DOCKET NO.: SUNSTAF-1026 PATENT

Serial No.: 10/618,945

Amendment dated April 21, 2006

Response to Office Action of January 25, 2006

FIG. 2

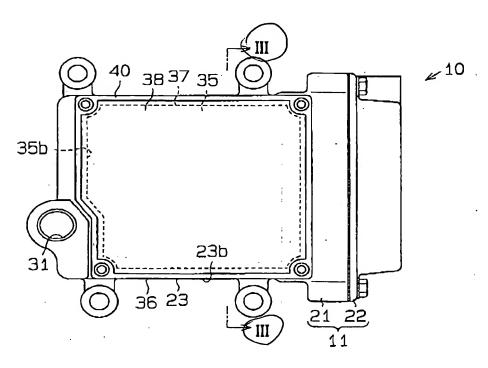
FIG.2 is replaced by the replacement sheet in which the numerals for indicating the plane upon which a sectional view is taken are changed from "I" to "III" to correspond to the view number of the sectional view.

The Examiner has objected to FIGURE 2. Accordingly, FIGURE 2 has been

amended as the Examiner has suggested as indicated above.

FIG. 3

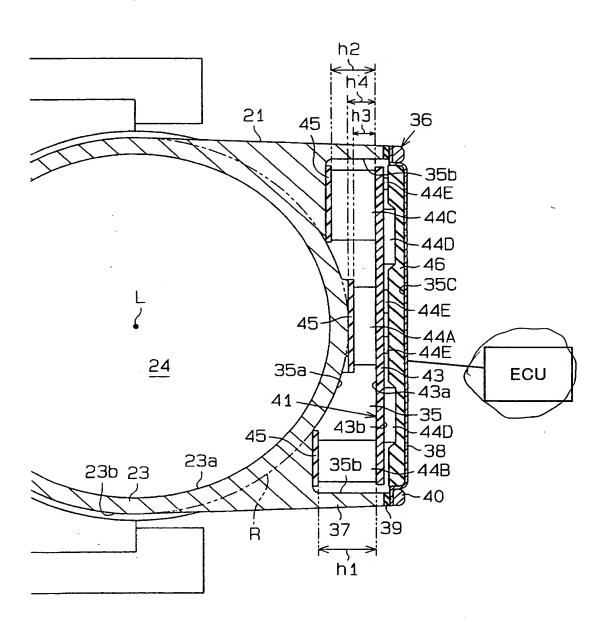
FIG. 3 is also amended to include an additional element, "ECU."
